Arkwood, Inc., Superfund Site
Comments on Revised Conceptual Site Model

Item No.	Reference	Comments by EPA Dated July 18, 2014	PRP Response Dated _____
1.	Revised CSM General	EPA has updated the Standard Default Exposure Factors used by the Superfund program: http://www.epa.gov/oswer/riskassessment/pdf/superfund-hh-exposure/OSWER-Directive-9200-1-120-ExposureFactors.pdf These Standard Default Exposure Parameters are used in the Regional Screening Level (RSL) calculator. http://www.epa.gov/region6/6pd/rcra_c/pd-n/screen.htm The RSL calculator shows, as of May 2014, the updated non-cancer screening level for 2,3,7,8-TCDD toxicity equivalent quotient (TEQ) for an industrial worker is 730 part per trillion (ppt).

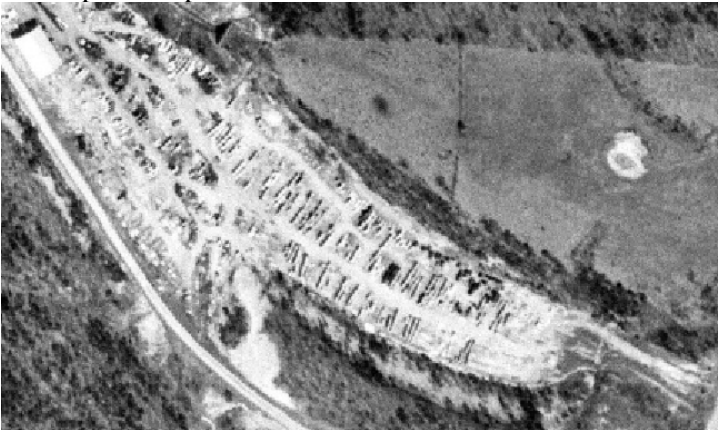
2. If the Chebyshev UCL does not exceed the decision threshold:
		      a. Evaluate the actual between-SU variability for this DU <u>AND in neighboring or similar DUs</u> for indications that the sampling design was inadequate to capture the full range of variability.

b. Determine the highest between-SU standard deviation (SD) among all similar DUs. Use this SD to recalculate Chebyshev UCLs for the DU.
		         i. If the Chebyshev UCL exceeds the decision threshold, follow Line #1 directly above.

Item No.	Reference	Comments by EPA Dated July 18, 2014	PRP Response Dated _____
		ii. If the Chebyshev UCL calculated with the worst case SD does not exceed the decision threshold, no additional sampling is needed. d. Because the SU-ICS samples do not represent estimates of the DU mean, the variability between SU-ICSs can be expected to be higher than the variability between DU-ICSs, which will increase the distance between the calculated mean and the UCL. e. Again, because the SU-ICS samples are not estimates of the DU mean, the t-UCL cannot be used unless there are enough SU-ICSs to establish that the distribution of SU-ICS results is normally distributed. Therefore, a 95% Chebyshev (nonparametric) UCL must be used. Chebyshev UCLs are higher than corresponding t-UCLs. f. At least 3 SU-ICSs are needed to calculate a reliable UCL for the DU. g. UCL calculations can be performed, or explored, using the Excel "ICS-95UCL calculator" which is programmed with the following UCL equations. **Student's-*t*** $$UCL = \bar{X} + t_{1-\alpha, r-1} \times \frac{SD}{\sqrt{n}}$$ **Chebyshev** $$UCL = \bar{X} + \left(\sqrt{\frac{1}{\alpha} - 1} \right) \frac{SD}{\sqrt{n}}$$
